Final Product/Process Change Notification

Document #:FPCN26459Z

Title of Change:	Lead Frame Design Change for TSOP6 NLVAS4599DTT1G Device at onsemi Seremban, Malaysia.
Proposed Changed Material First Ship Date:	30 Aug 2025 or earlier if approved by customer
Current Material Last Order Date:	N/A <i>Orders received after the Current Material Last Order Date expiration are to be considered as orders for new changed material as described in this PCN. Orders for current (unchanged) material after this date will be per mutual agreement and current material inventory availability.</i>
Current Material Last Delivery Date:	N/A <i>The Current Material Last Delivery Date may be subject to change based on build and depletion of the current (unchanged) material inventory</i>
Product Category:	Active components – Integrated circuits
Contact information:	Contact your local onsemi Sales Office
PCN Samples Contact:	Contact your local onsemi Sales Office to place sample order. Sample requests are to be submitted no later than 45 days after publication of this change notification. Samples delivery timing will be subject to request date, sample quantity and special customer packing/label requirement

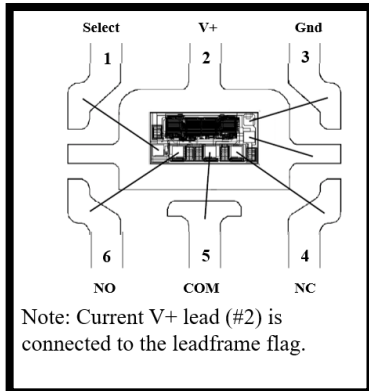
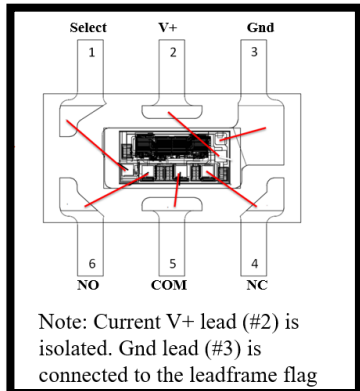
From	To		
LeadFrame Design	<ul style="list-style-type: none">Current V+ lead (#2) is connected to the leadframe flag. <div></div>	<ul style="list-style-type: none">Current V+ lead (#2) is isolated.Gnd lead (#3) is connected to the lead frame flag. <div></div>		
Note: There are no product material changes as a result of this change.				
Reason / Motivation for Change:	Process/Materials Change			
Anticipated impact on fit, form, function, reliability, product safety or manufacturability:	<p>The device has been qualified and validated based on the same Product Specification. The device has successfully passed the qualification tests. Potential impacts can be identified, but due to testing performed by onsemi in relation to the PCN, associated risks are verified and excluded.</p> <p>No anticipated impacts.</p>			
Sites Affected:				
onsemi Sites	External Foundry/Subcon Sites			
onsemi Seremban, Malaysia	None
